AGENDA

MATANUSKA-SUSITNA BOROUGH

ABBREVIATED PLAT AGENDA ASSEMBLY CHAMBERS 350 EAST DAHLIA AVENUE, PALMER

April 16, 2025

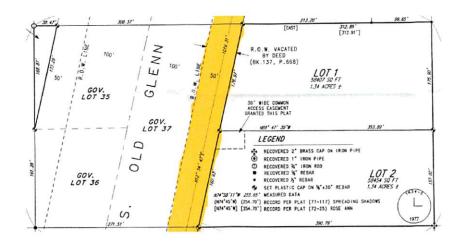
Before DOT&PF can issue an access permit, DOT&PF expects to see codified agreement across fee interest under previously vacated right of way interest per deed BK.137, P.668 and as highlighted in the below diagram.

DOT&PF cannot permit legal access unless an access right through the right of way is shown.
